Proposed Revisions to a Standard Plans Index

Index Number: 641-020

Index Title: CONCRETE CCTV POLE

Summary of the changes:

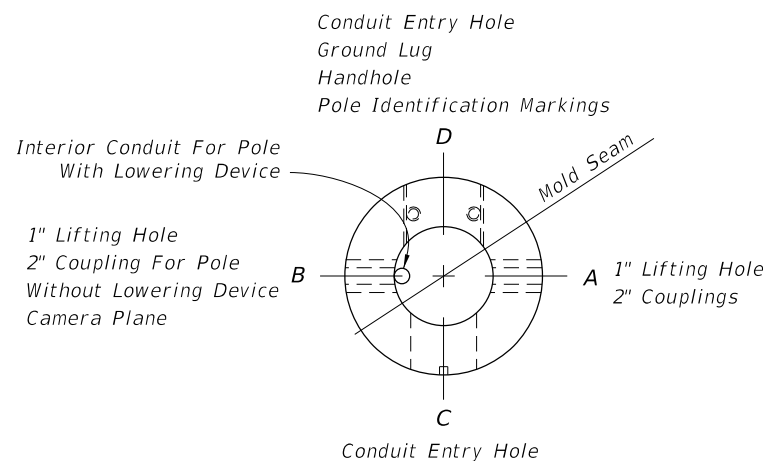
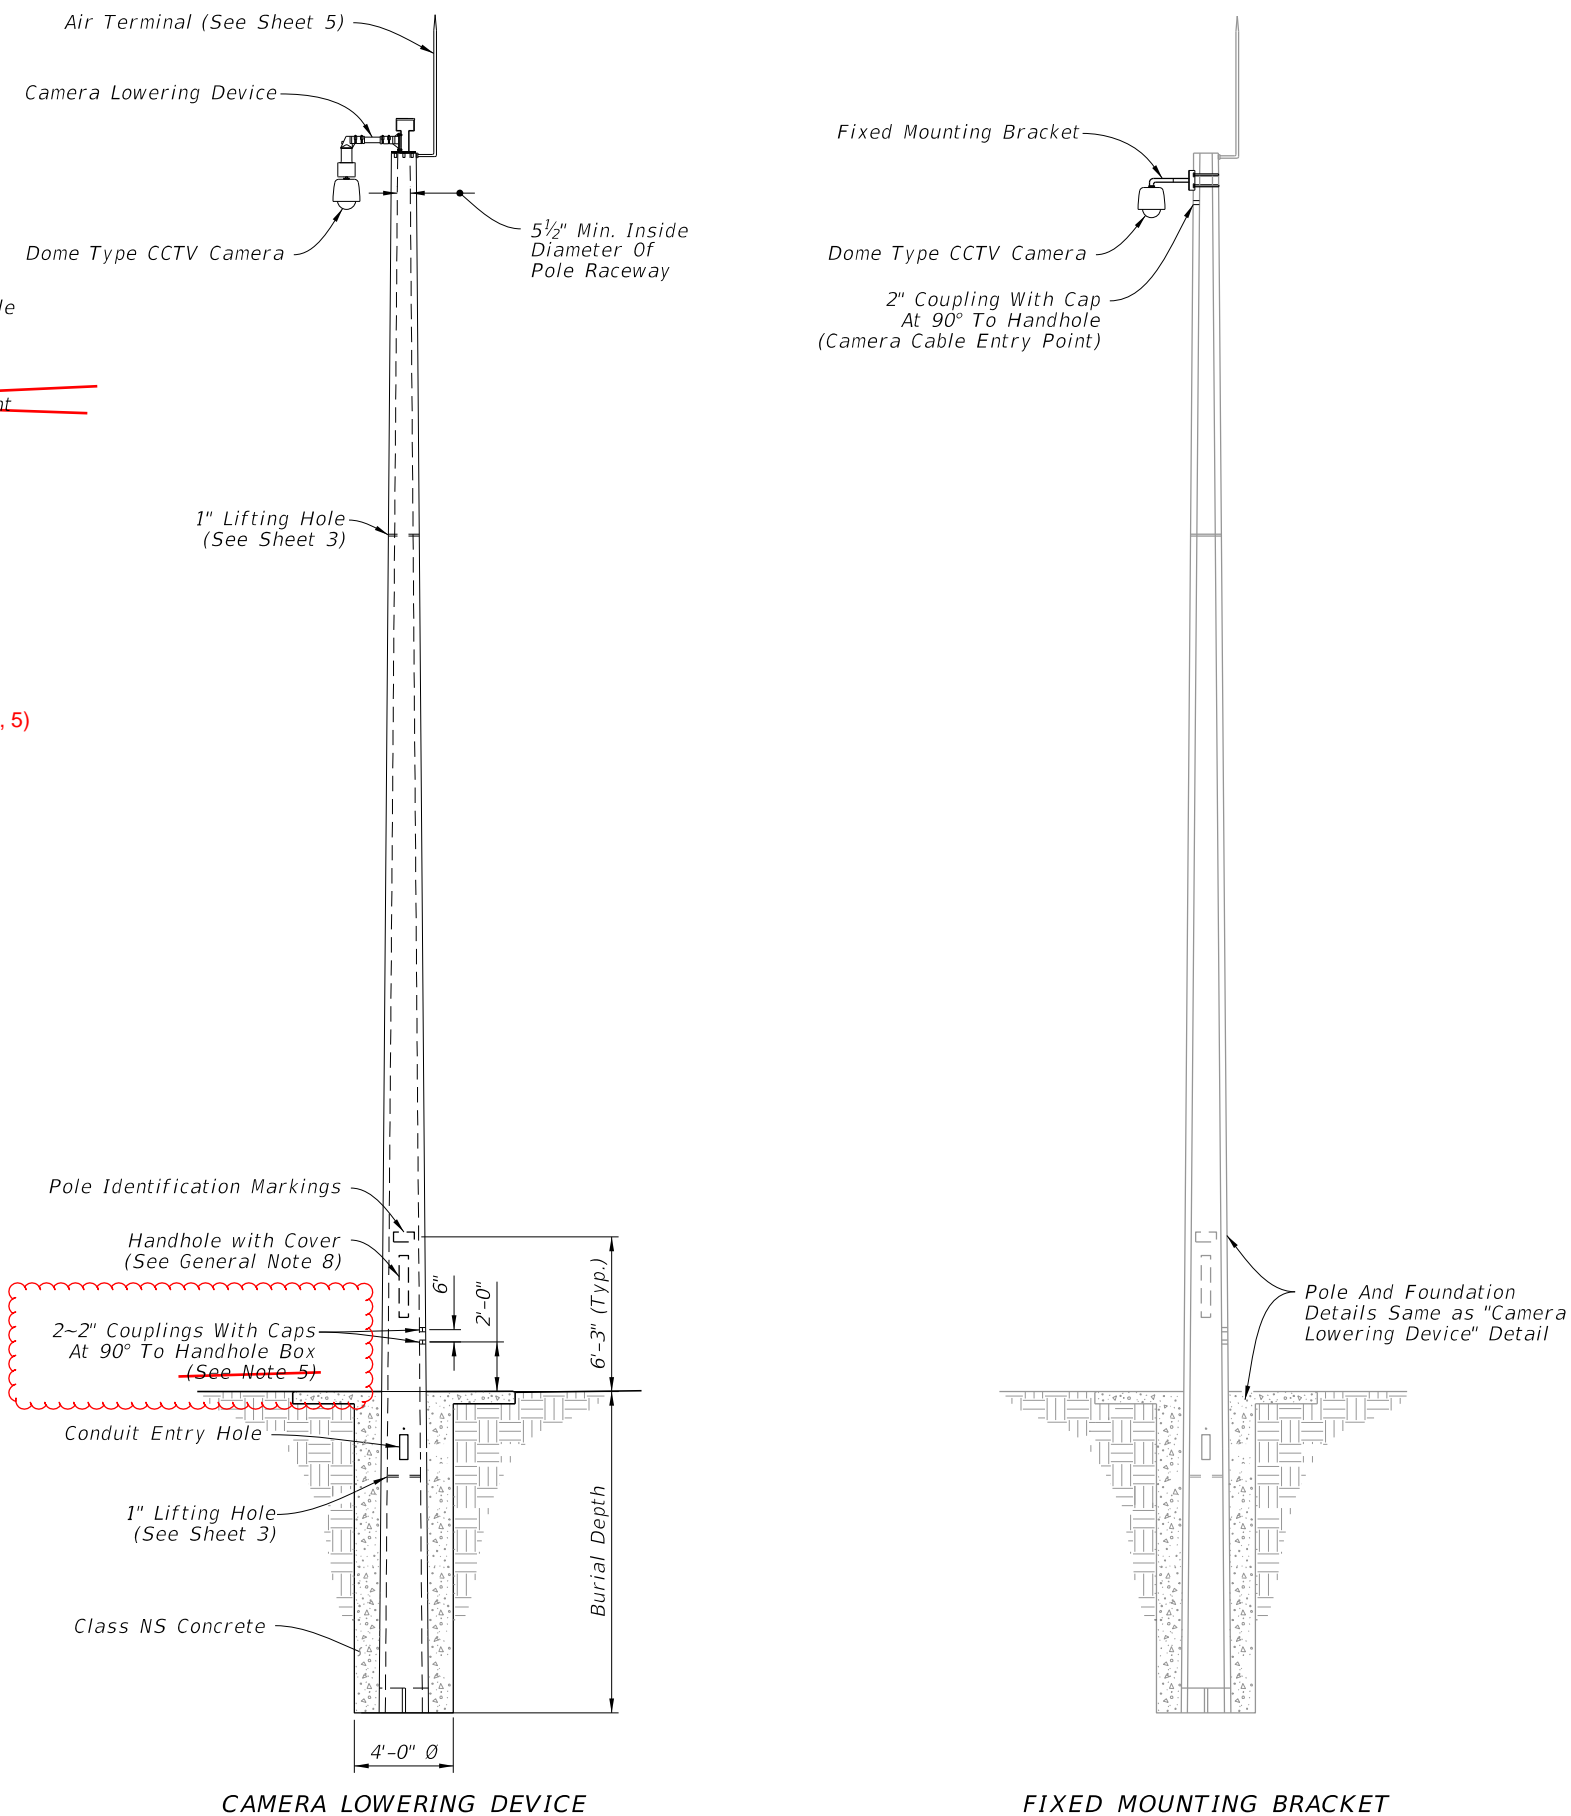
Sheet 2: Added note allowing additional strand pattern and updated associated tables.

5. Strand Pattern 1 may be used in lieu of Strand Pattern 2 where required by fabrication to facilitate Handhole construction.

(See Note 1, 5)

LAST REVISION 11/01/21	REVISION 11/01/23	DESCRIPTION:	FDOT	FY 2023-24 STANDARD PLANS	CONCRETE CCTV POLE	INDEX 641-020	SHEET 3 of 5
---------------------------	----------------------	--------------	------	------------------------------	--------------------	------------------	-----------------

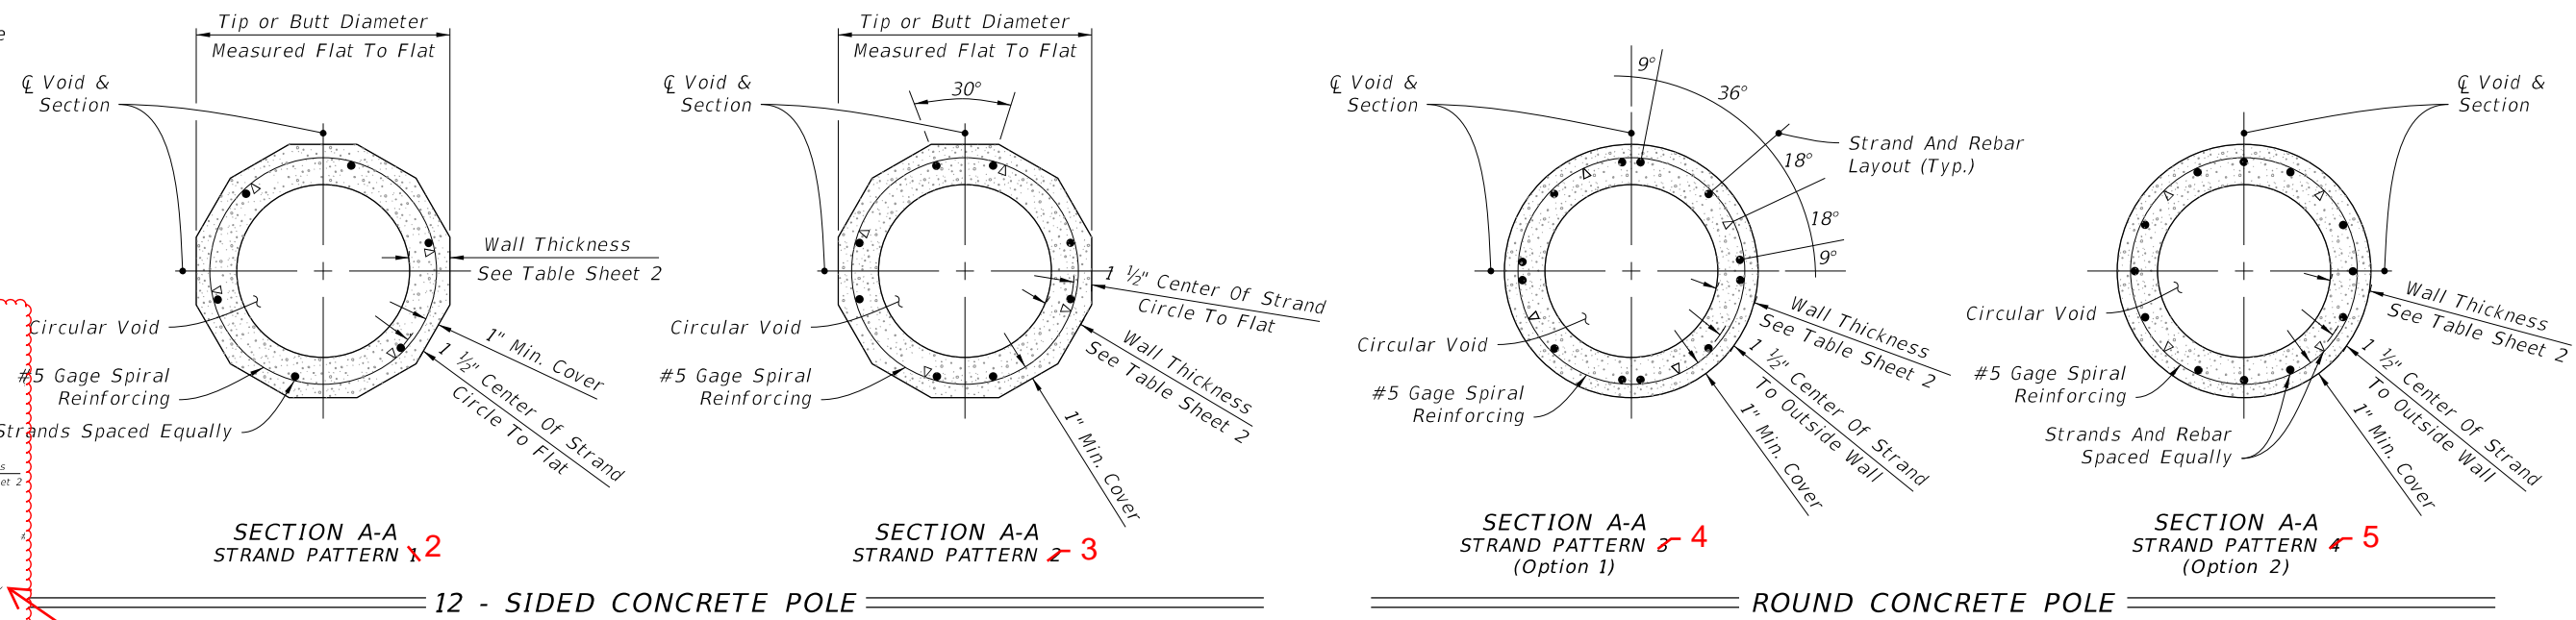
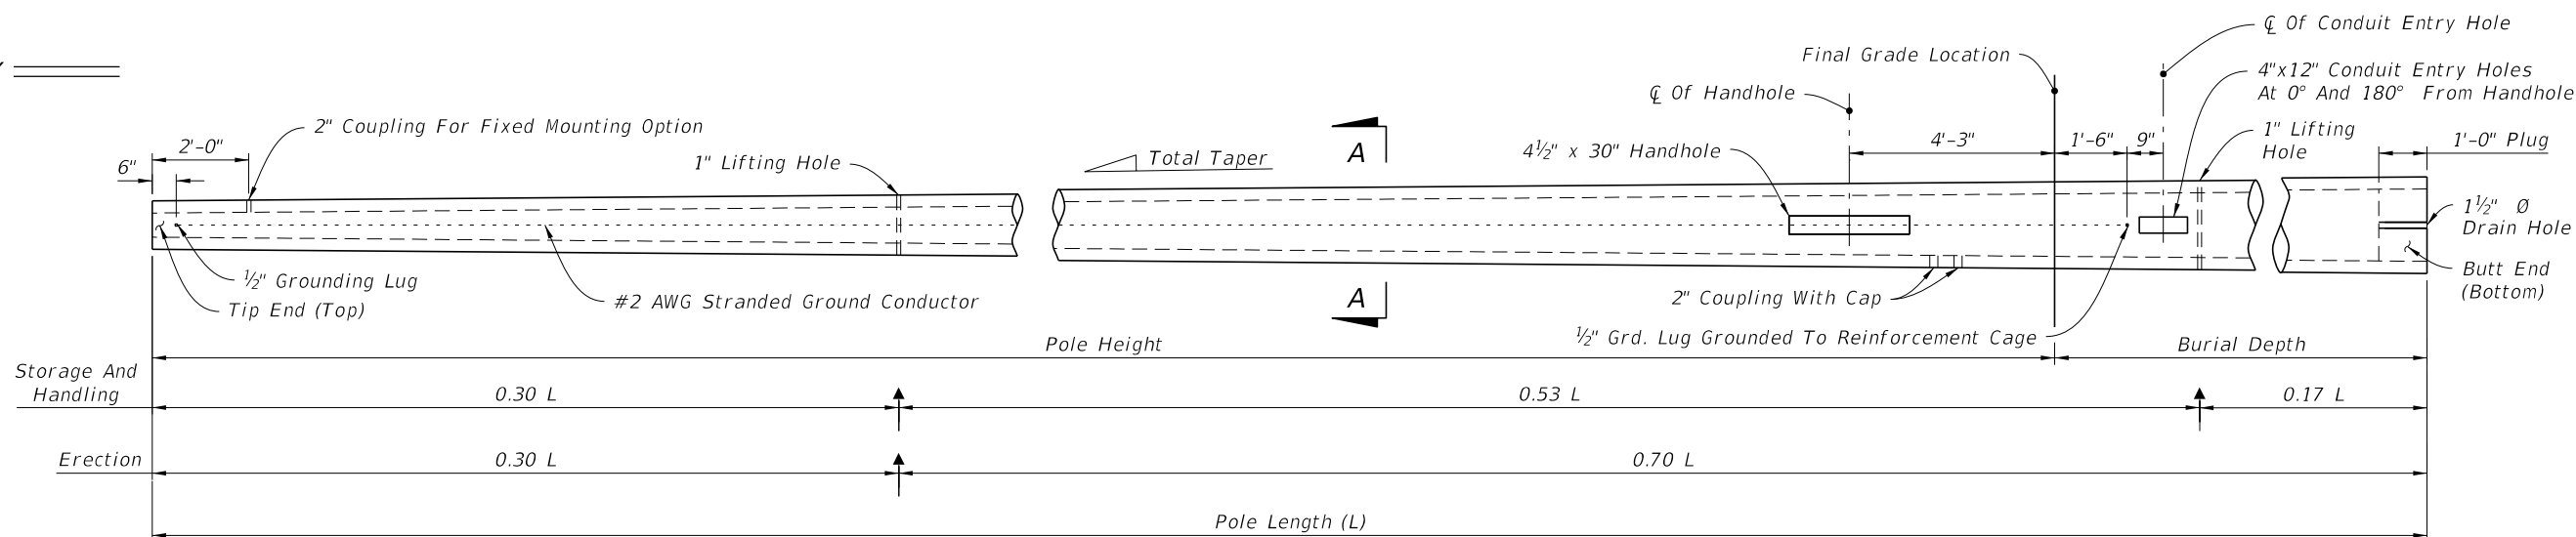
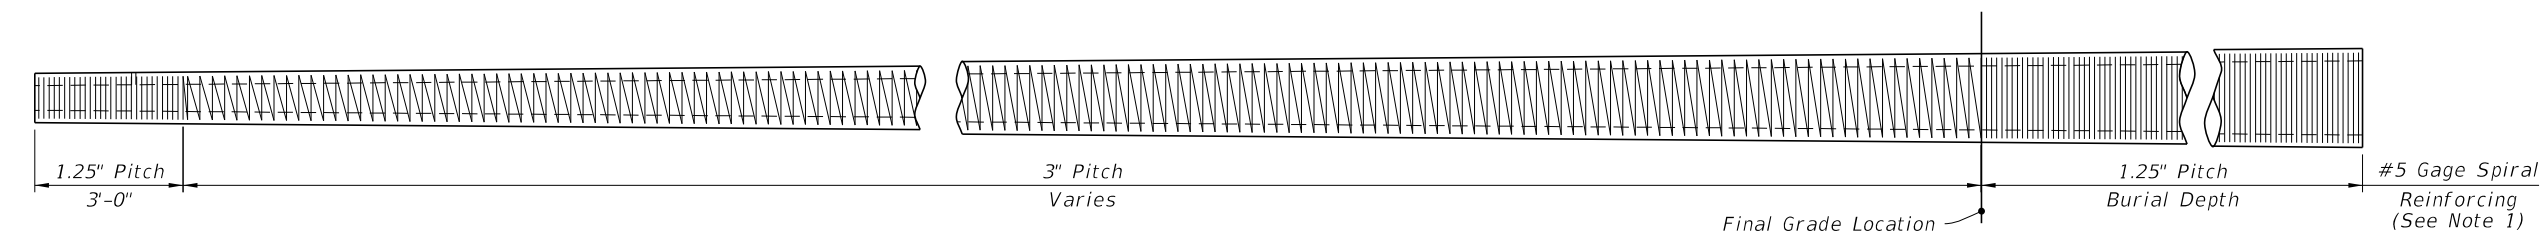
Sheet 3: Added a new strand pattern.

Sheet 3: A fabricator of 12 sided poles had an approved strand pattern in their QC plan which differed from the Standard. The difference allowed the fabricator to mount the hand hole on the flat of the pole and maintain reinforcement cover. We have adopted this in the Standard to provide consistency between the QC plan and the Standard.

Added New Strand Pattern Detail
